MUNCIE POWER PRODUCTS

Product Bulletin #00086

Subject: TITAN® MC1 Clutch Pack Changes

Date: Effective April 25, 2020

The order of the clutch plates is as shown in Figure 1.

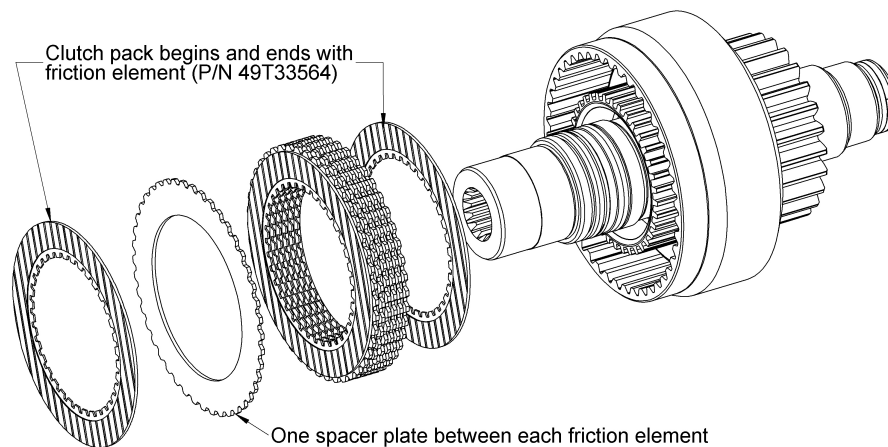
An inline change is being made to the clutch pack components of the TITAN® MC1 PTO. The clutch spacer plates and friction elements in the TITAN MC1 family of PTOs have now been updated to include the same components as used in the CS24 family of PTOs. There are no changes to the torque ratings of the PTO.

The P/Ns and quantities are as follows.

Friction Elements - 49T33564 (8 pcs)

Spacer Plates - 49T40641 (7 pcs)
